Addition of a Logo to CC-Link IE TSN Remote Modules

■Relevant Models

FA-A-0334-A

1.1 Position of the Logo (for the NZ2GN2S1-32D)

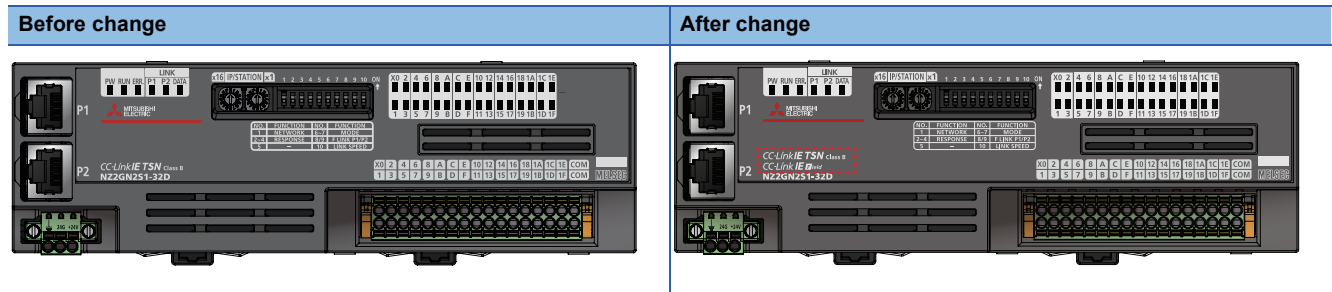
The logo of "CC-Link IE Field" is added on the front of the module as follows.

The position of the logo may differ depending on the model.
